UNITED STATES PATENT AND TRADEMARK OFFICE

APPLICATION NO.	FILING DATE	FIRST NAMED INVENTOR	ATTORNEY DOCKET NO.	CONFIRMATION NO.
10/709,580	05/14/2004	Paul K. MEEKER	43064-0030	3579

Office Action Summary	Application No. 10/709,580	Applicant(s) MEEKER ET AL.	
	Examiner Joseph F. Edell	Art Unit 3636

DETAILED ACTION

Diagram A - Annotated Figure 8 of Burleigh et al.

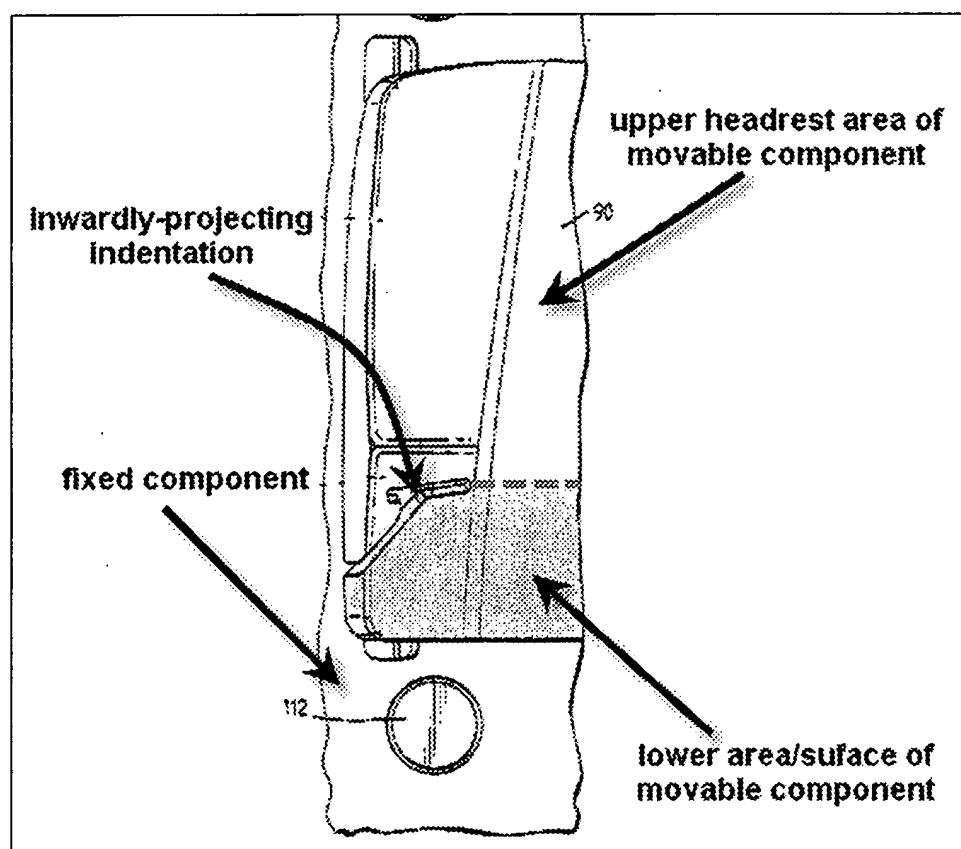
Burleigh et al. disclose a car seat that includes all the limitations recited in claims 1-8, 10-20, 22-30, and 32. Burleigh et al. show a seat having a seat member 72 (see Fig. 5), a back member 78 connected to the seat member, a fixed component (see Diagram A below) of the back member including raised contoured sides 80,82 (see Fig. 6) and contoured surface in cross-section, a movable component 90 of the back member including raised contoured sides 92,94, capable of movement from a retracted position to an extended position, and overlapping the fixed component, an upper headrest area of the movable component (see Diagram A) with a pair of forward extending wings, and an opposed lower area (see Diagram A) separated from the upper headrest area by a pair of fixed size inwardly-projecting indentations 126,128 (see Fig. 8 and Diagram A) to accommodate a shoulder belt, fixedly connected to the upper headrest area, and including a surface and a contour in cross-section mating the contoured surface of the fixed component.

Burleigh et al. show a back member wherein the upper headrest area being in invariant fixed relationship to the lower area and separated by the indentations (see Diagram A), the movable component is attached in front of the fixed component, the fixed and movable components being in overlapping essentially gapless relationship with respect to each other with sliding movement between the components at both the retracted and extended positions (sliding movement of shoe parts 118 along tracks 96,98 - see Fig. 6 - allowing for the gapless relationship), the sliding movement between

the components does not increase a size of the indentations between the upper headrest area and lower area, and means for selectively positioning and retaining the movable component relative to the fixed components (the shoe parts and tracks are functionally equivalent to the positioning and retaining structure described in the instant application) that permits incremental discrete movement or infinitely variable movement and is a pair of outwardly biased shafts 118 capable of locking, and telescoping movement of the movable component relative to the fixed component which is fixed by a length of longitudinal channels 96,98 in the fixed component.
